ADDENDUM #08

PROJECT: **UPPER POTTS GROVE TOWNSHIP NEW MUNICIPAL COMPLEX**
PROJECT #: **22-0058**
ISSUE DATE: **May 16, 2024**

EROSION & SEDIMENTATION CONTROL PLAN

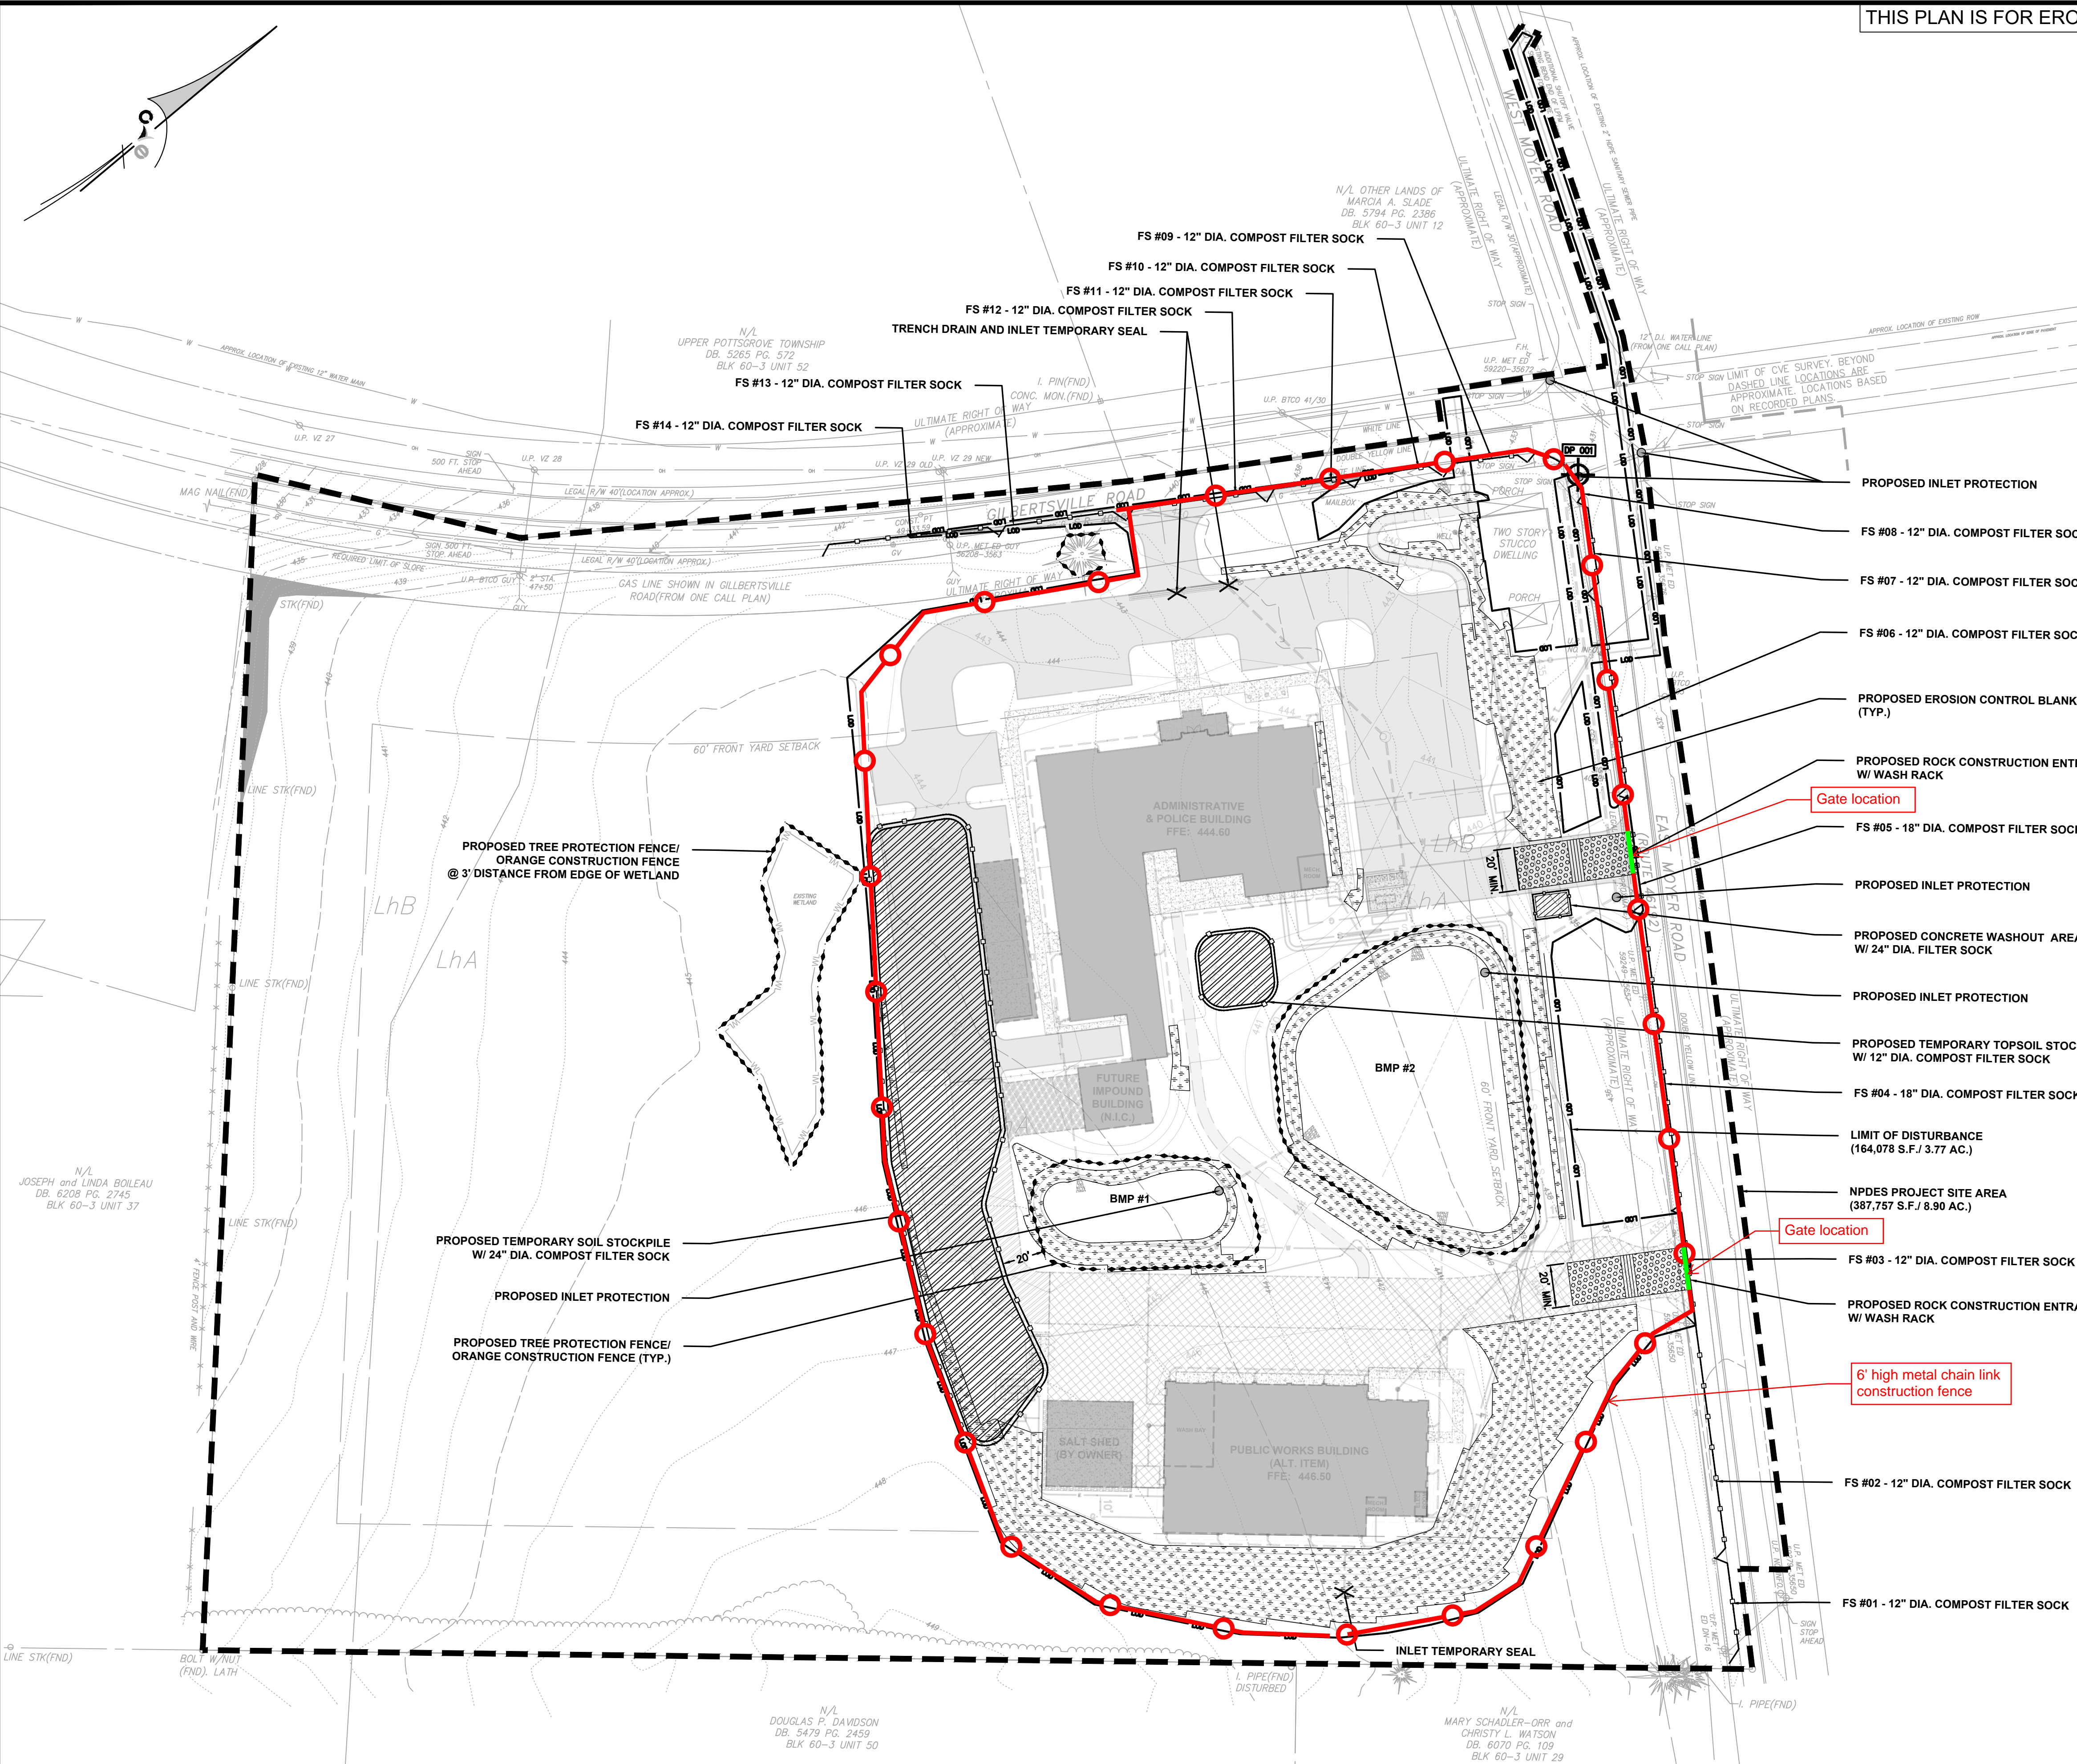
a. **06.ES-1 'EROSION & SEDIMENT CONTROL PLAN'**
